ADDENDUM NO. 1
TO
SPECIFICATIONS
FOR THE
GLOUCESTER CITY BOARD OF EDUCATION
CONTRACT #06 – MEDIA CENTER AND MAIN OFFICE ALTERATIONS
AT
GLOUCESTER CITY MIDDLE SCHOOL

Gloucester City Board of Education
1300 Market Street
Gloucester City, NJ 08030

LAN Job #2.20457.06
January 10, 2024

1 1ST FLOOR PROPOSED MAIN OFFICE PLAN
A2.01 1/8" = 1'-0"

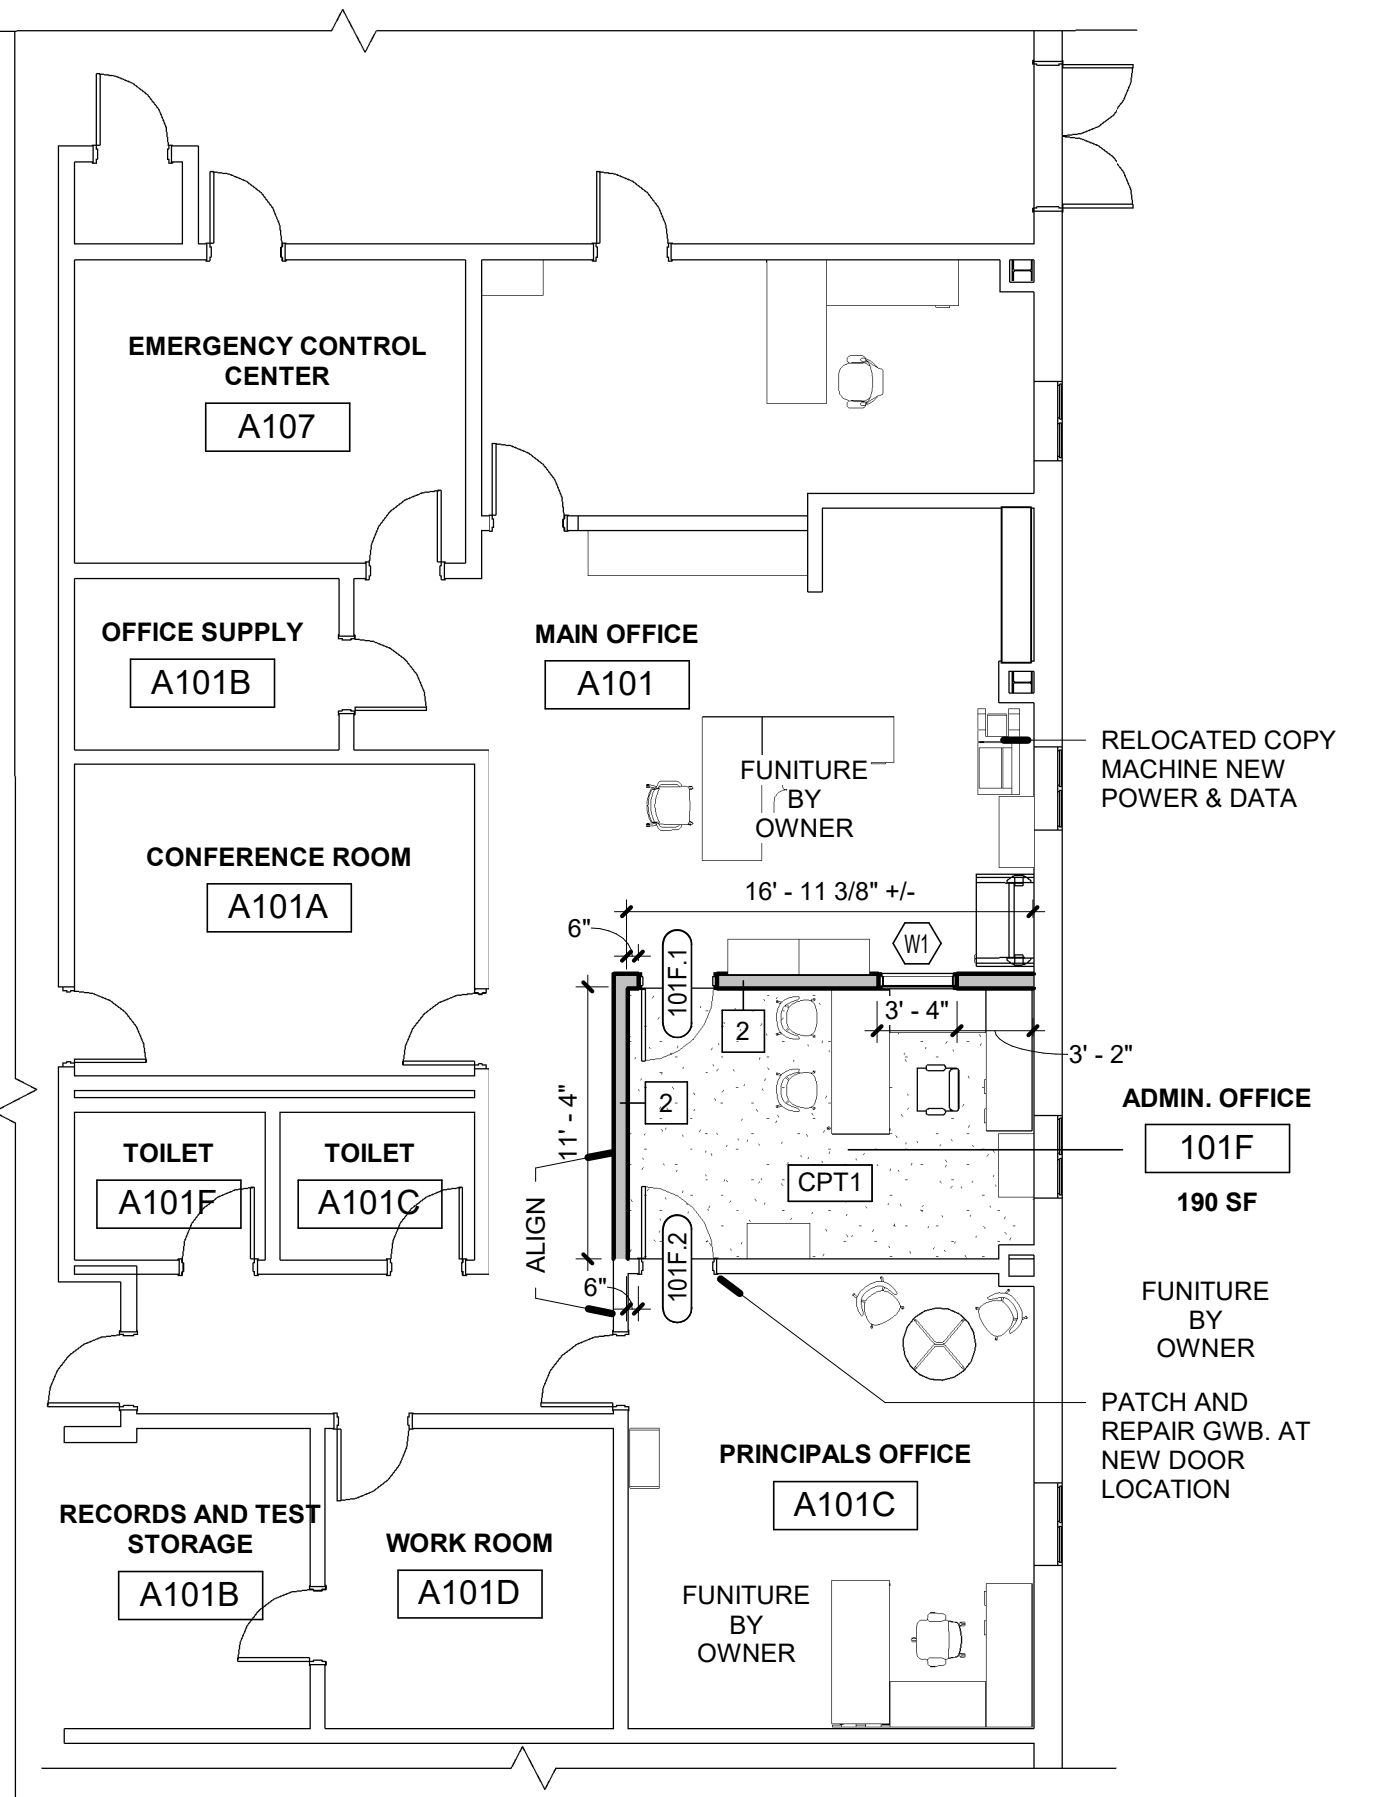
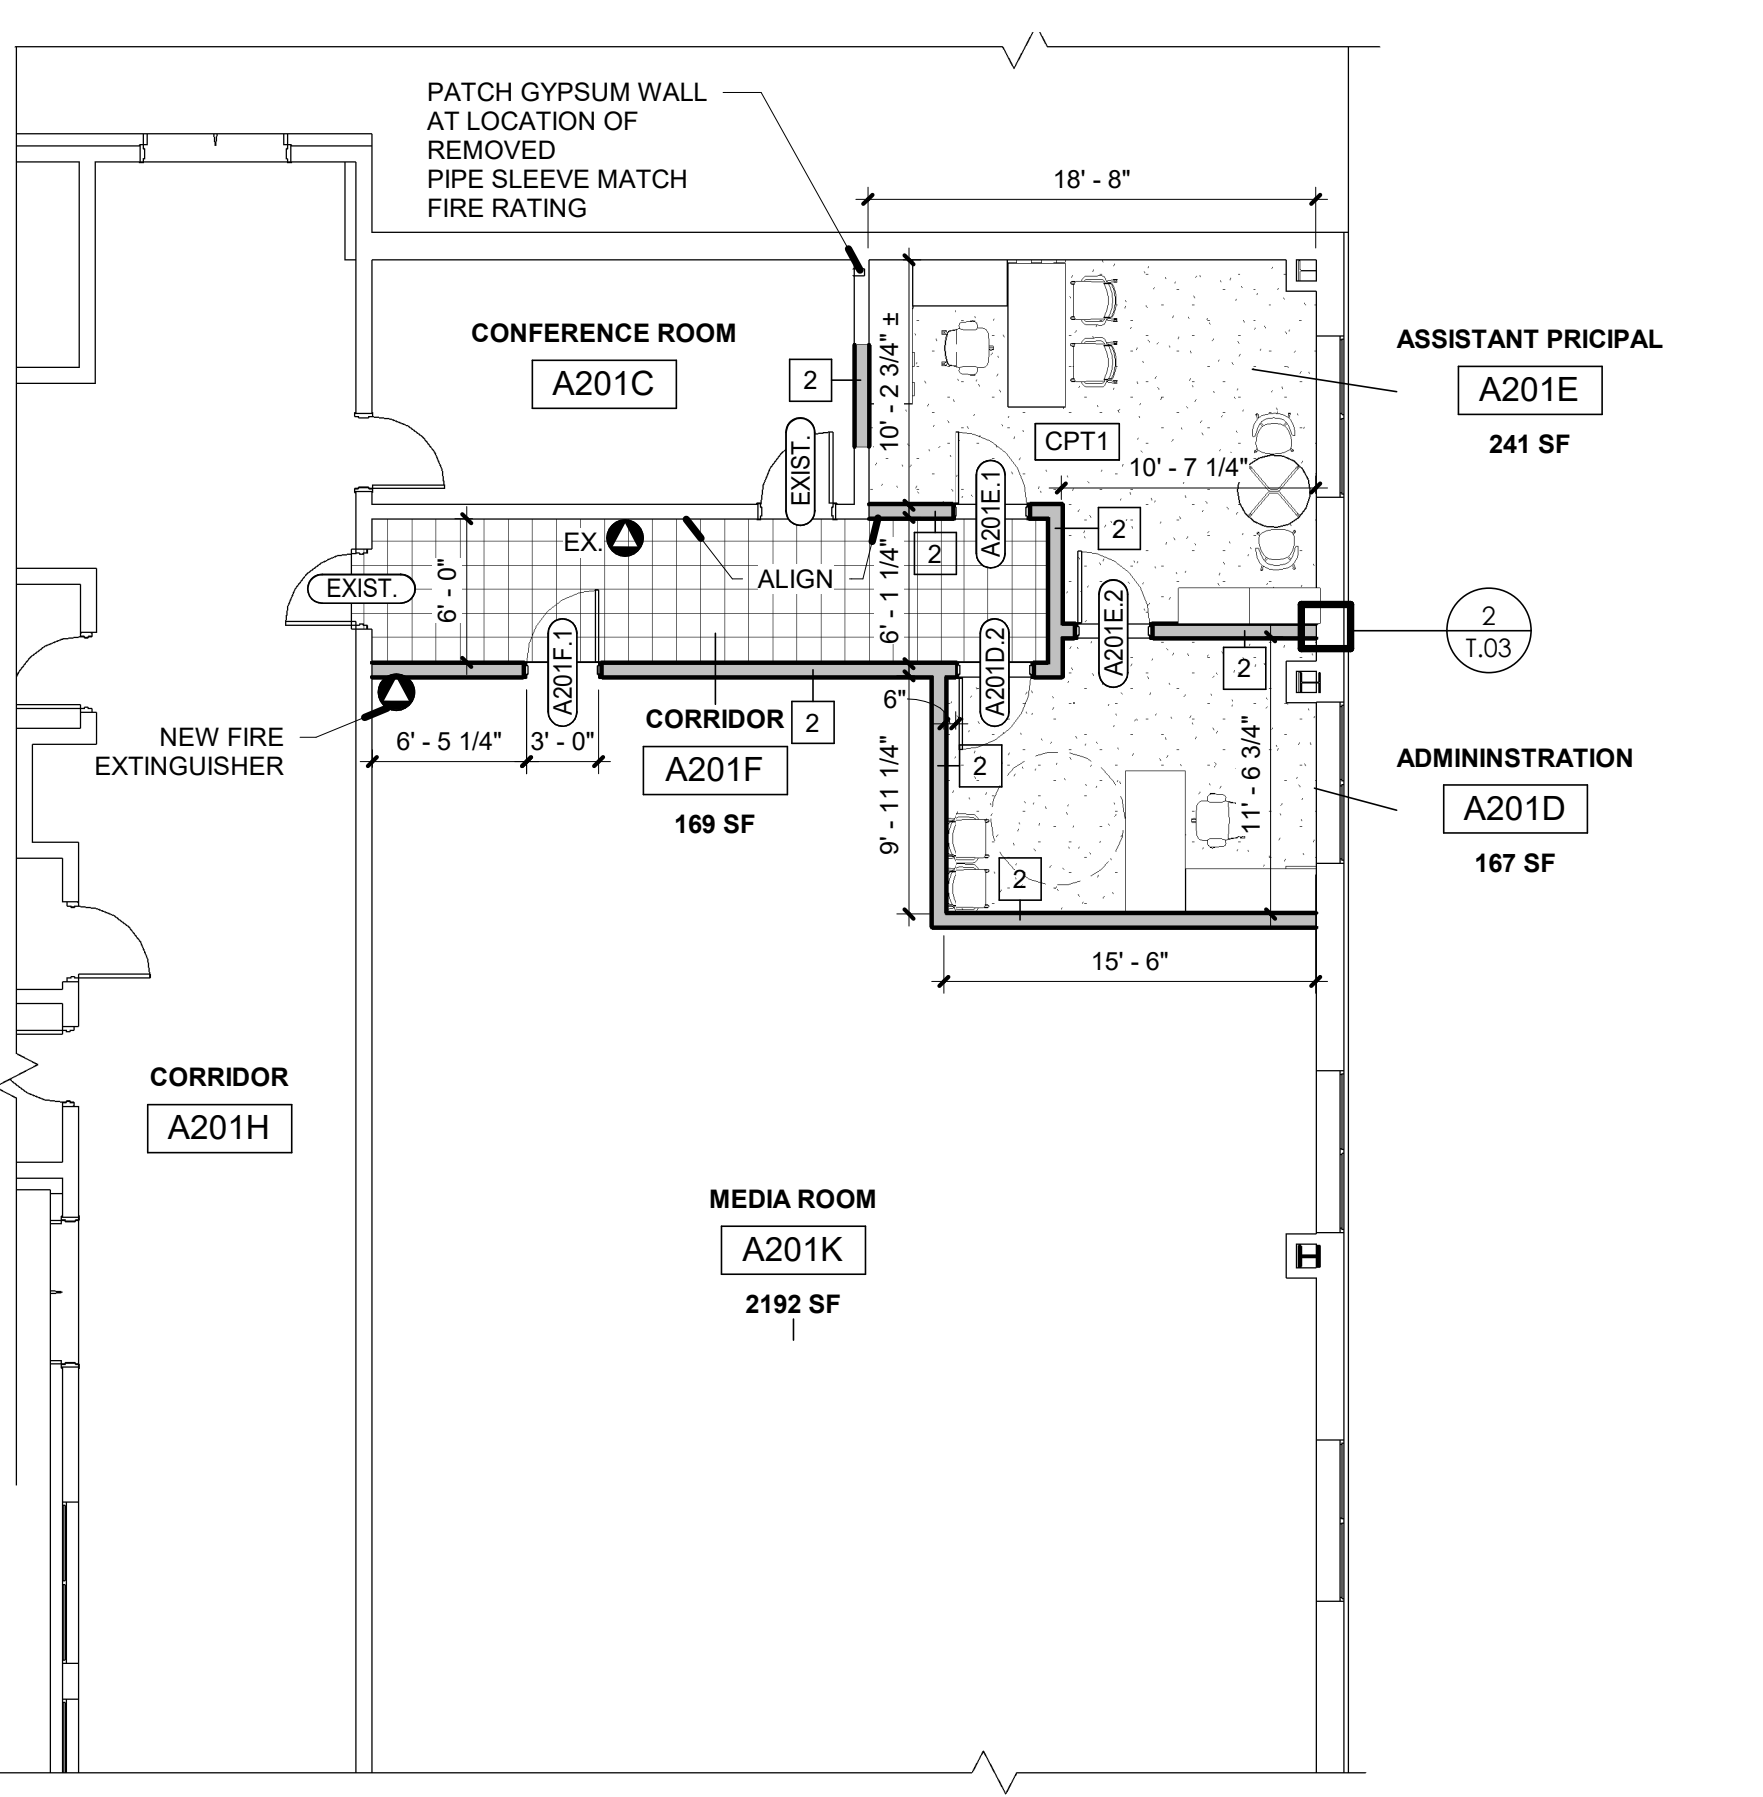
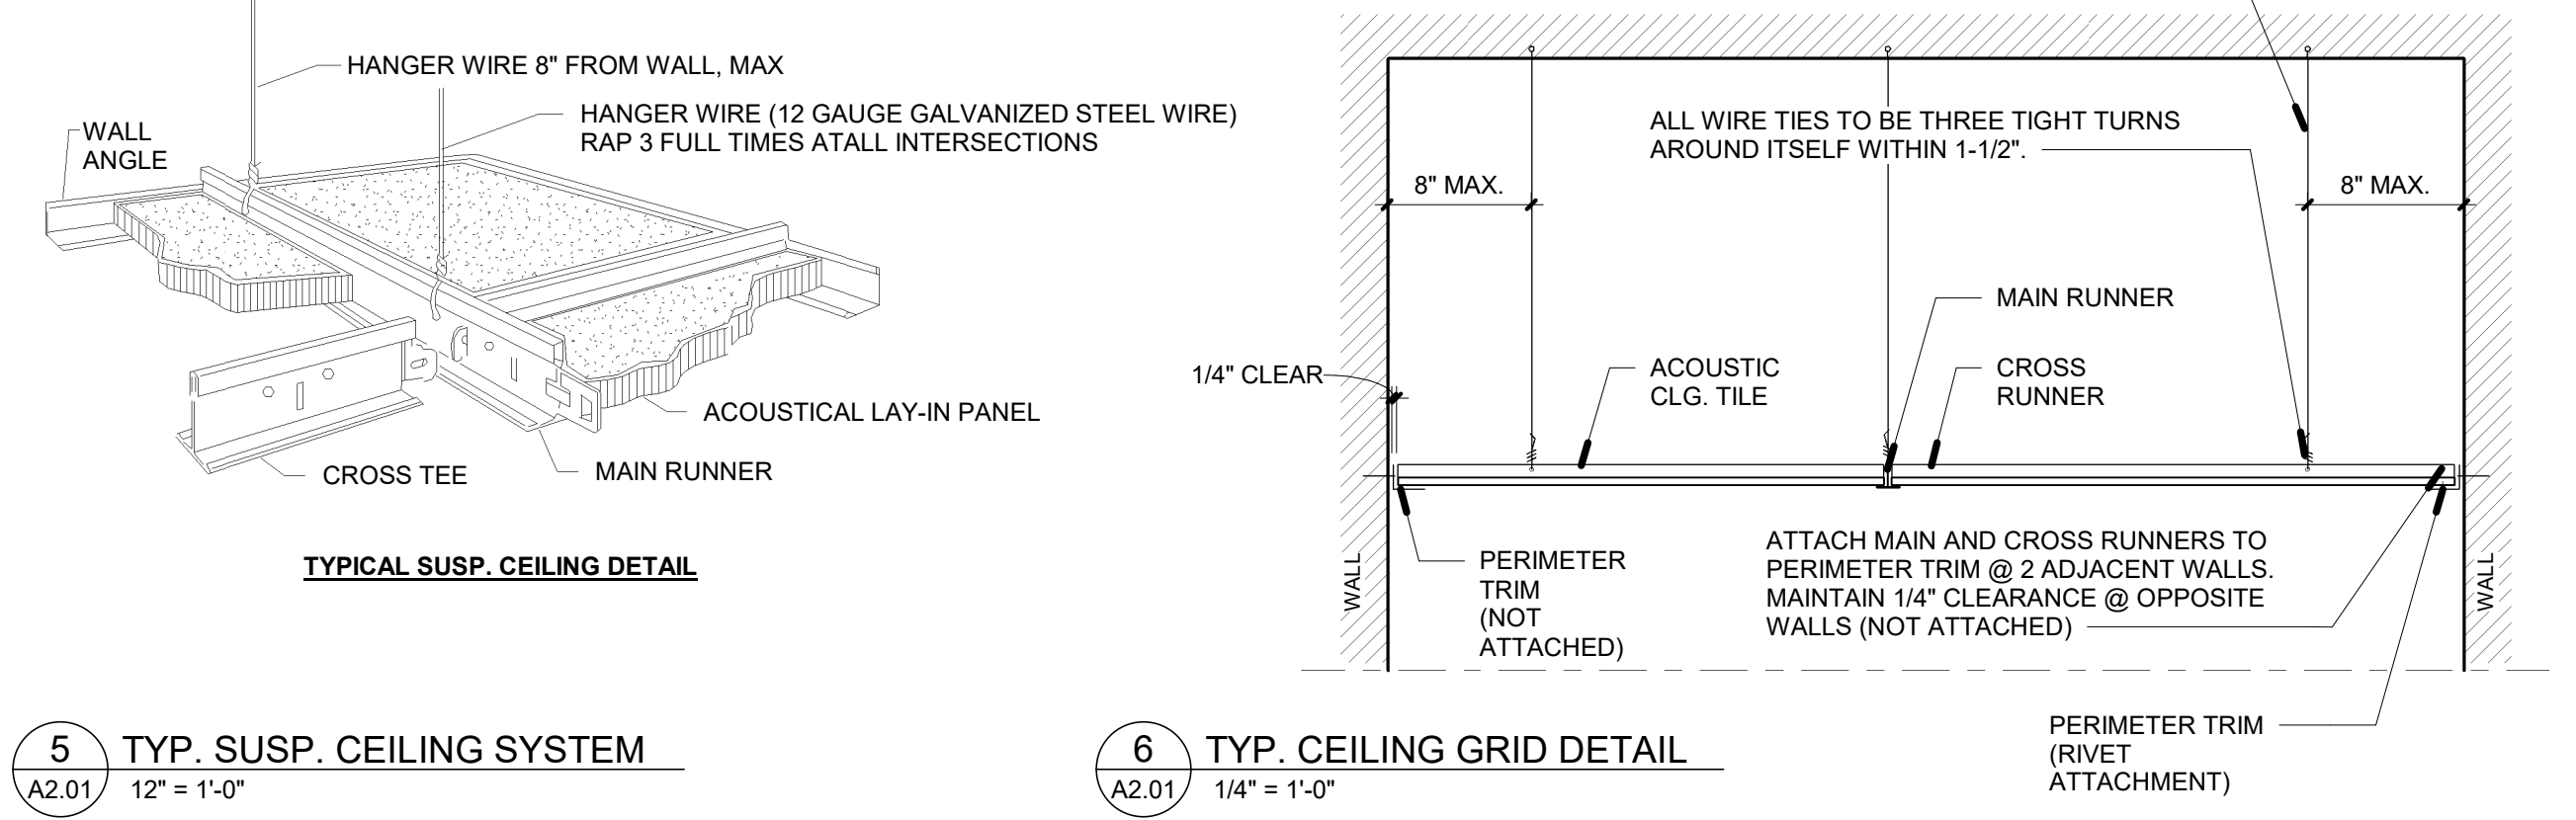
8. Q: Can the architect confirm rooms on the finish schedule? There are rooms on the drawing sheet that are marked as CPT 1 and not on the finish schedule.

A: Refer to revised finish schedule on Drawing Sheet A2.01, Enclosure #3 attached.
